# **Mount Piper to Wallerawang Transmission Line Upgrade Project**

Amendment Report

December 2025

Figure 2.7 Amendment 1 - New temporary culvert

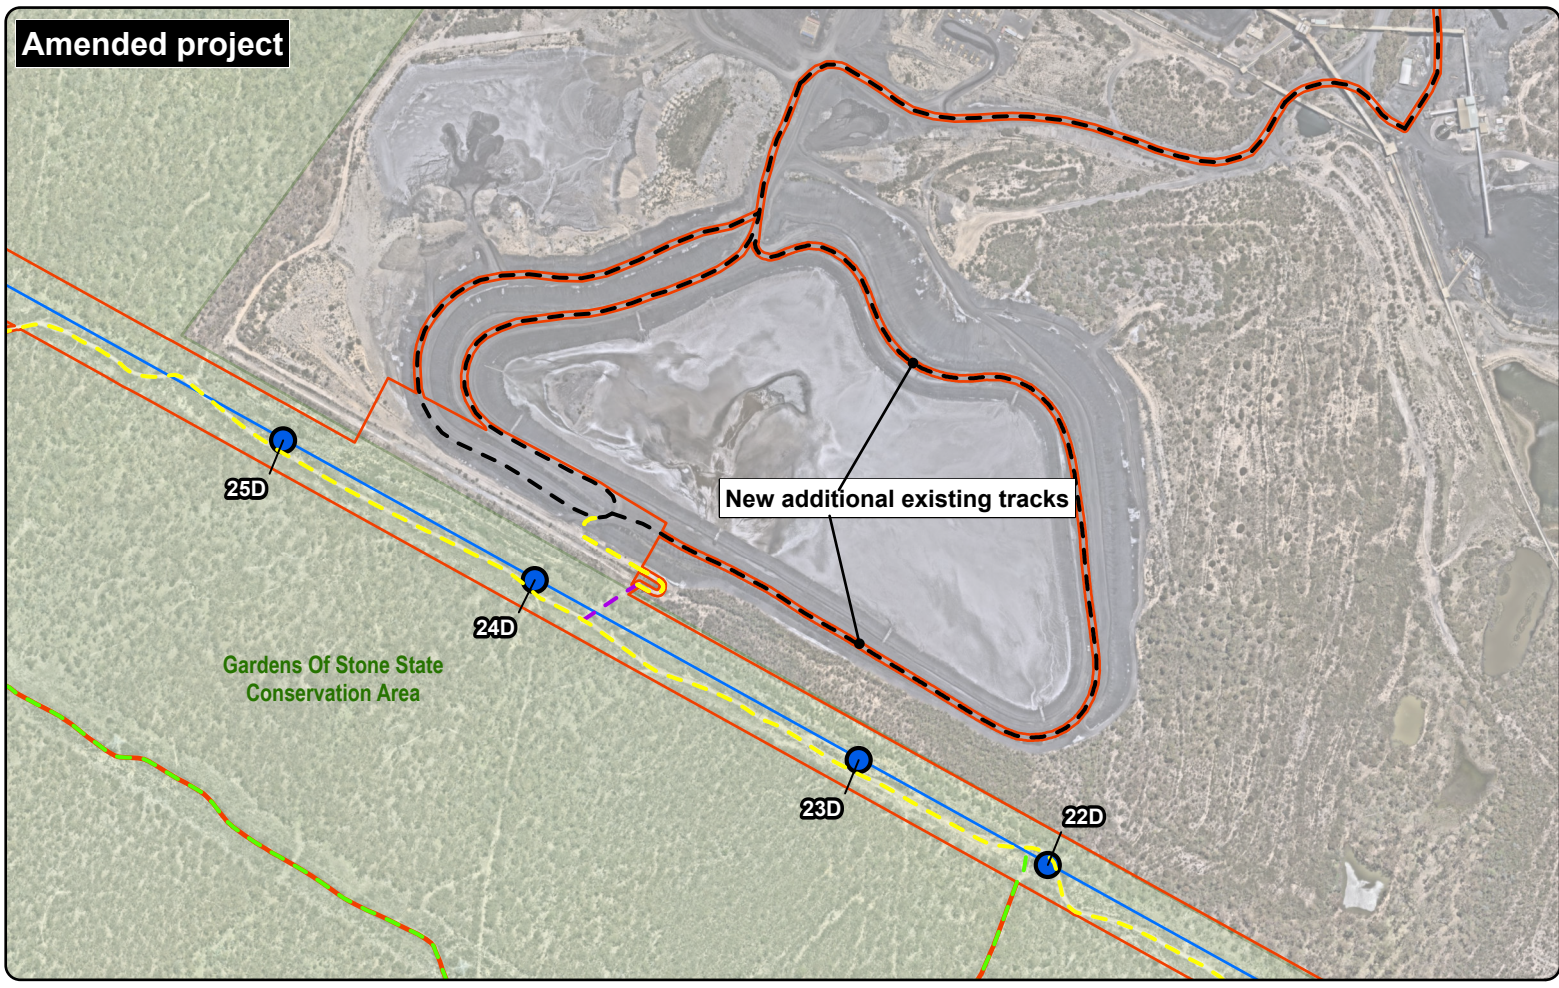
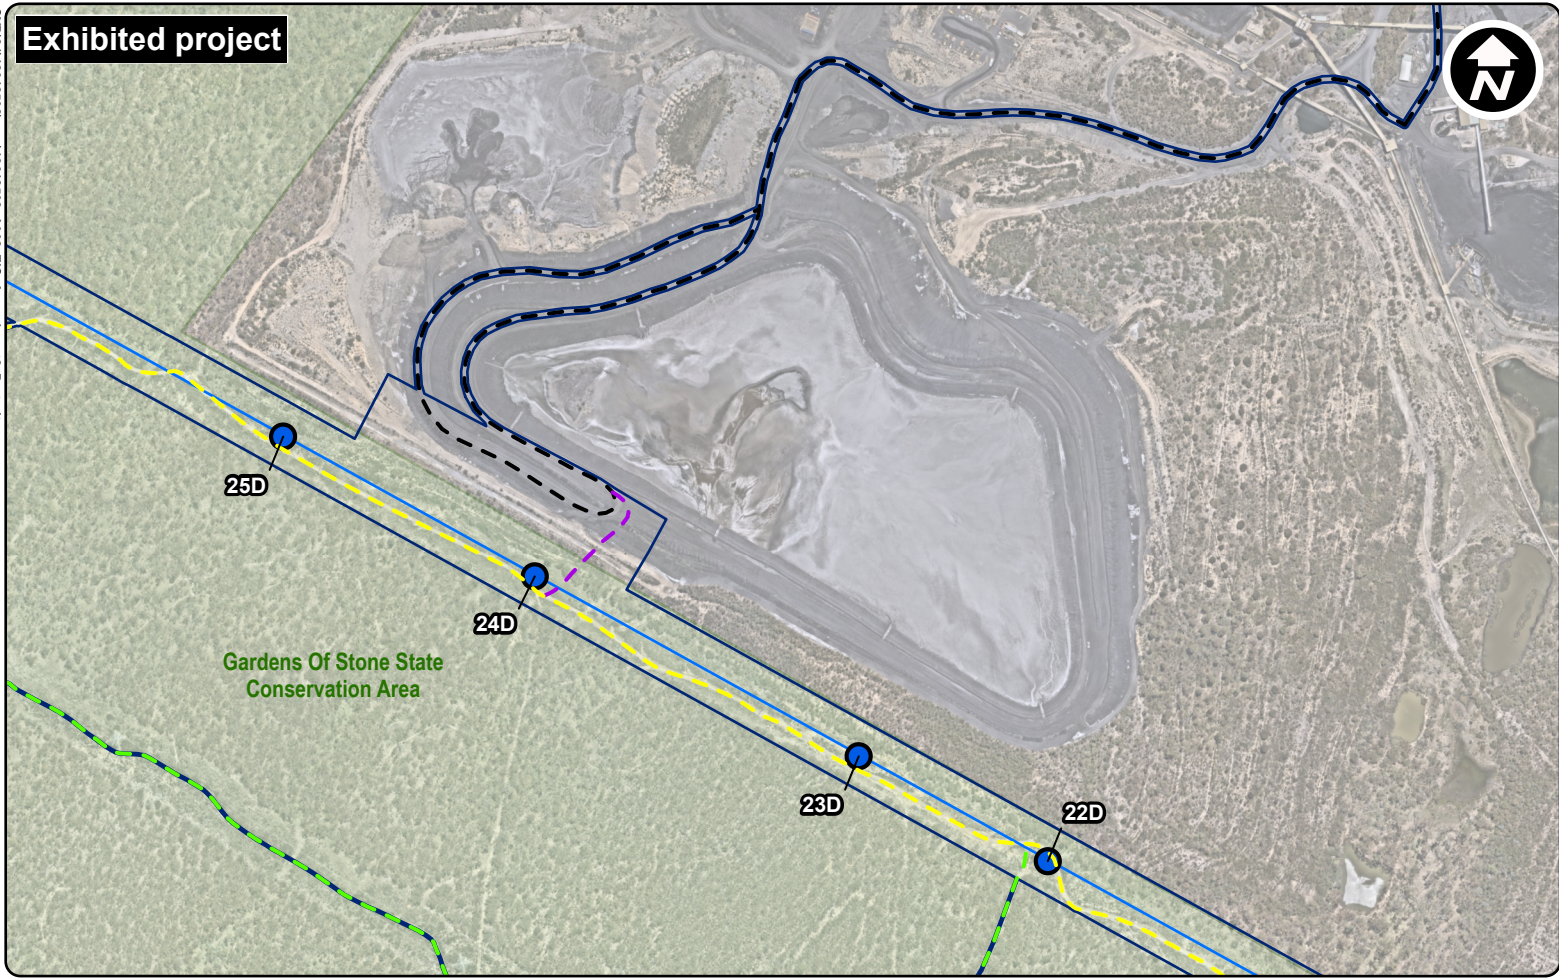
No.	Proposed amendment	EIS description	Amendment description	Reason for amendment	Figure reference
1	New temporary culvert over unnamed creekline on existing track near Mount Piper 330 kV substation.	Widening of existing access track to 6 m at this location, with no proposed culvert over unnamed creekline.	<p>A temporary culvert would be installed across the existing track where it crosses an unnamed creekline.</p> <p>The temporary culvert would comprise dual 600 mm pipes covered with approximately 300 mm of engineered fill. The culvert and fill would be removed following completion of construction.</p> <p>All works would be within the project footprint outlined in the EIS (Transgrid, 2025a).</p>	The temporary culvert is required to facilitate heavy vehicle movements safely across this low point in the topography and maintain uninterrupted streamflow (when flowing).	Figure 2.1
2	Use of additional existing tracks on the Centennial Springvale Coal Services facility and a segment of a new track.	Using existing tracks around the northwest side of Centennial Coal's reject emplacement area to gain access to the existing easement in the vicinity of TS24D.	<p>To facilitate access to the proposed easement in the vicinity of TS24D, it is proposed to:</p> <ul style="list-style-type: none"> <li>• use an existing Centennial Coal track within the reject emplacement area</li> <li>• upgrade and widen an existing Centennial Coal track located between the reject emplacement area and the easement</li> <li>• construct a new 6 m wide access track from the abovementioned track south of the reject emplacement area to the easement.</li> </ul> <p>A section of track proposed in the EIS (Transgrid, 2025a) would no longer be required.</p>	<p>Centennial Coal has requested the potential use of specific additional tracks to minimise disruption to their operations. During construction, the identification of which tracks will be used would be decided in consultation with Centennial Coal based on their operations at the time.</p> <p>Changes to the access track south of the reject emplacement area is the result of further construction planning and consideration of specific topographical constraints.</p>	Figure 2.2

Figure 2.3 Amendment 3 - Upgrade of an additional existing access track east of TS14D – map 1

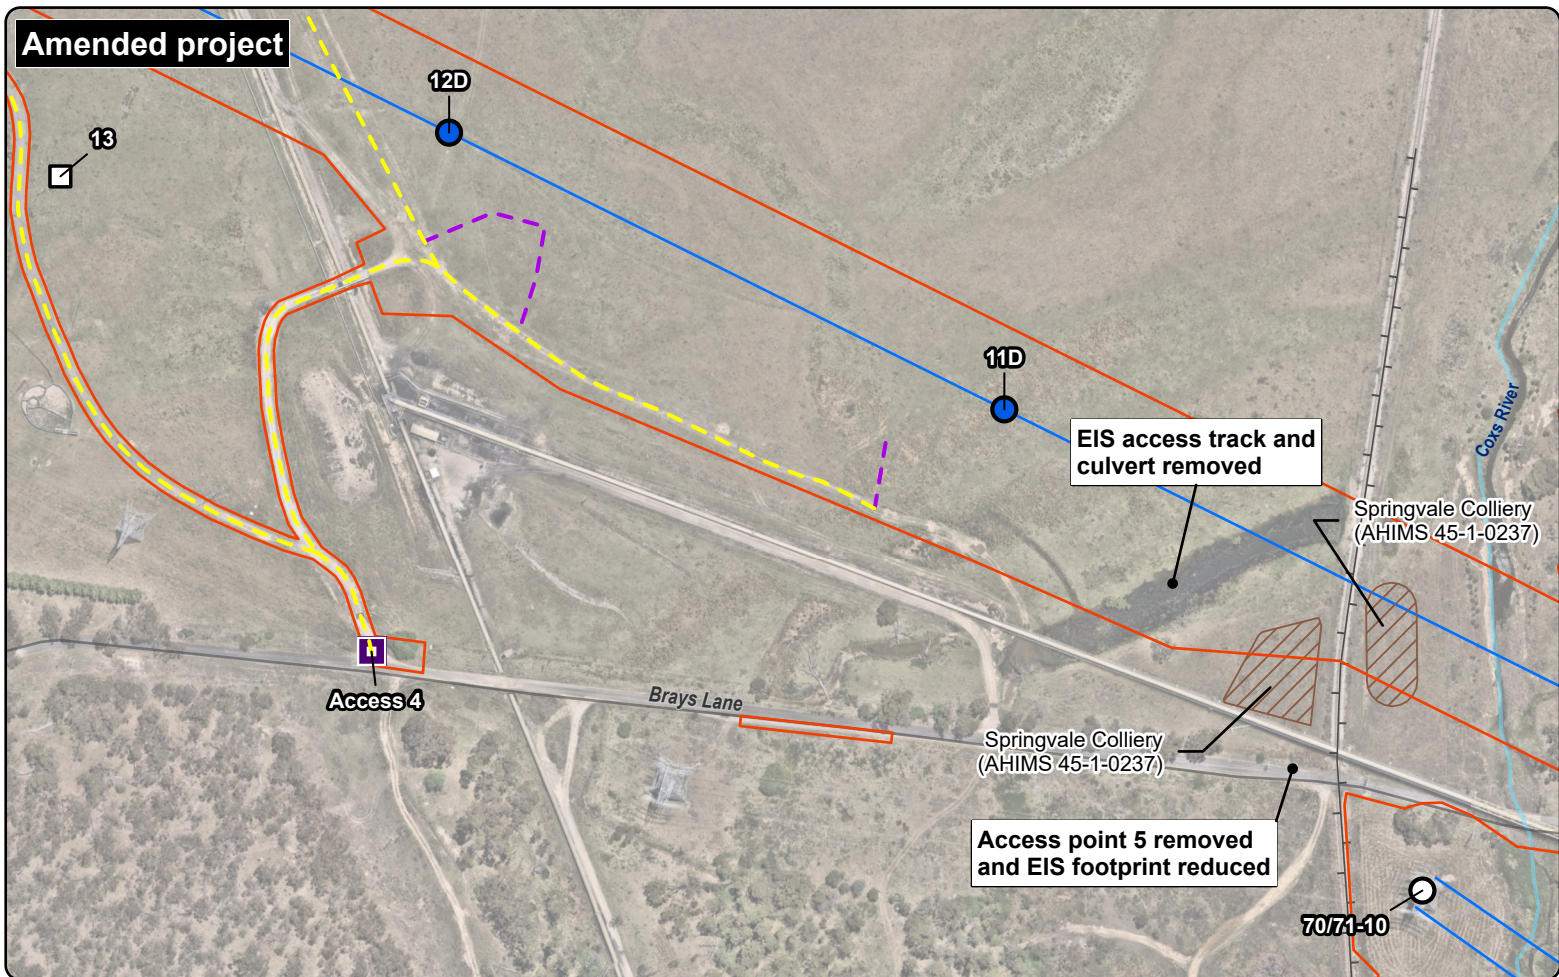
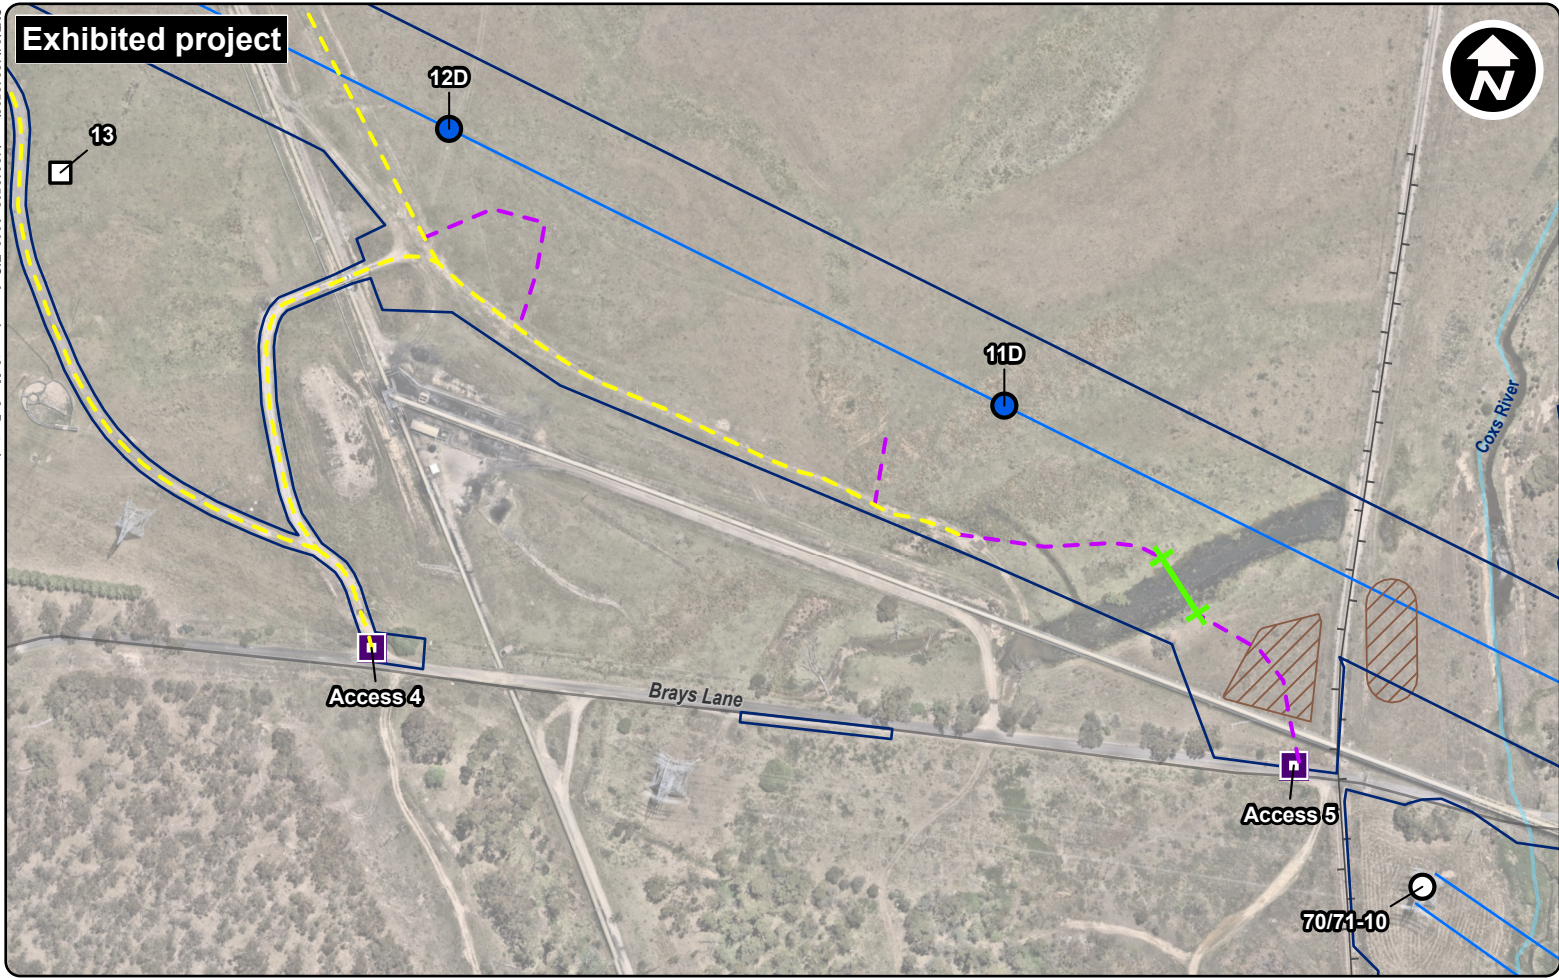
No.	Proposed amendment	EIS description	Amendment description	Reason for amendment	Figure reference
3	Upgrade of an additional existing access track east of TS14D	TS11D and 12D would be accessed via access point 5, on Brays Lane, and a new 6 m wide track that crosses the Springvale Colliery Aboriginal heritage site (AHIMS 45-1-0237). This track includes a new culvert over an existing waterbody, the unnamed tributary (oxbow) of Cox's River.	<p>An existing track east of TS14D would be upgraded and widened to connect tracks included in the EIS project footprint. This would provide access to TS11D and TS12D from the west, passing under the existing Centennial Coal overland conveyor.</p> <p>The track would be widened to 6 m, and to 8 m wide under the coal conveyor to accommodate heavy vehicle turn paths. No tree clearing would be required and the existing farm dam would not be impacted.</p> <p>Use of this upgraded track would eliminate the need for construction of the new track between access point 5 and TS11D, including the proposed culvert. The need for access point 5 would also be removed with movements to utilise access point 4 instead. A portion of the project footprint has been removed, as it was originally included to facilitate construction of the access track that is no longer required.</p>	<p>Changes to these access tracks are the result of ongoing construction planning activities to enable:</p> <ul style="list-style-type: none"> <li>further avoidance and minimisation of the risk of impacts on the Springvale Colliery Aboriginal heritage site (AHIMS 45-1-0237)</li> <li>efficiencies in construction and reduction of impacts by removing the need for a new culvert and a new access point.</li> </ul>	Figure 2.3

Figure 2.5 Amendment 4 and 5 – Changes to TS 10D laydown area and brake and winch site and adjustment of project footprint near access point 7 on Brays Lane

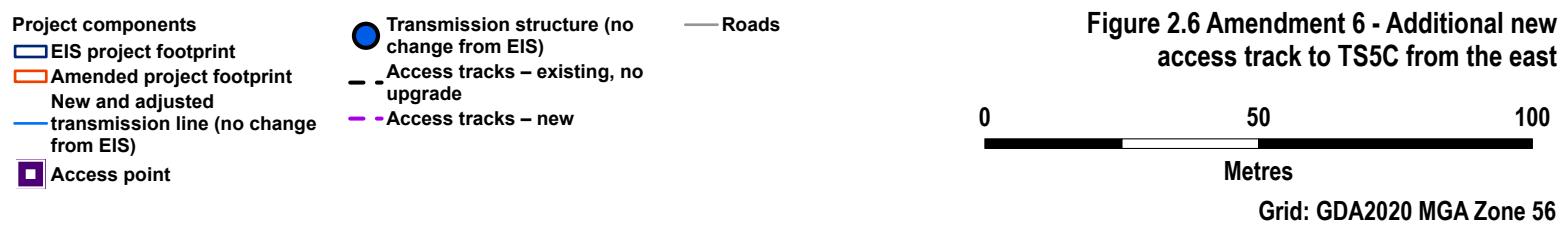
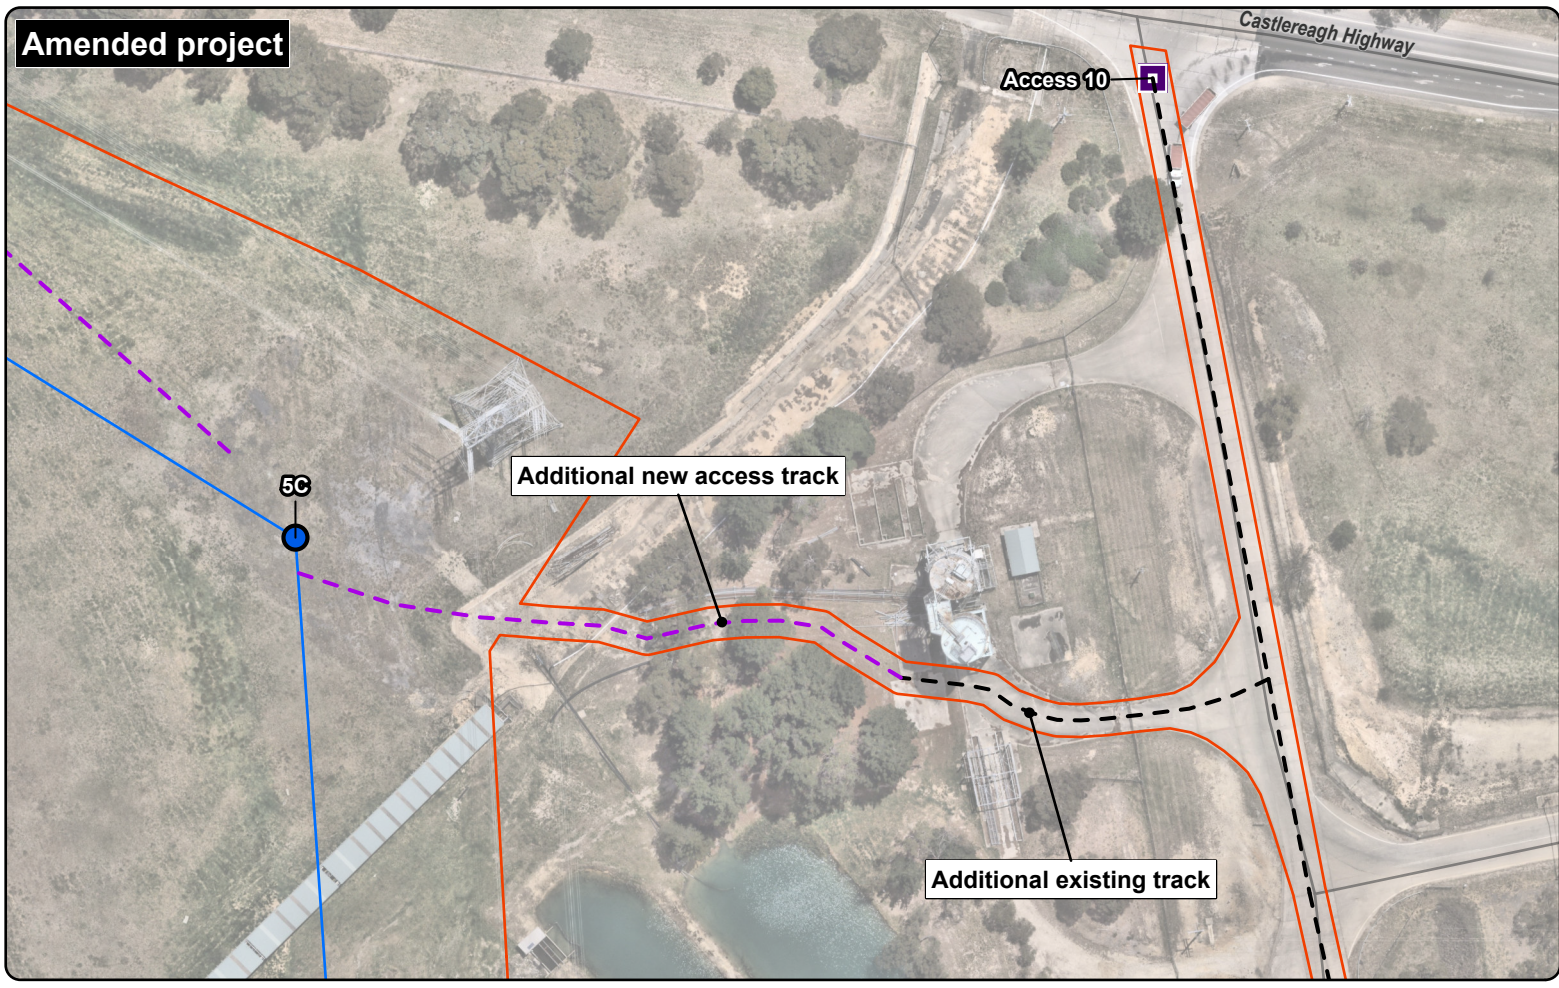
5	Adjustment of project footprint near access point 7 on Brays Lane	About 10 m of existing track (from access point 7) was not captured in the EIS project footprint.	A minor adjustment to the project footprint is required to include the full access track from access point 7 beneath the existing Centennial Coal overland conveyor.	The change is required to ensure all required access tracks are included in the project footprint.	Figure 2.5
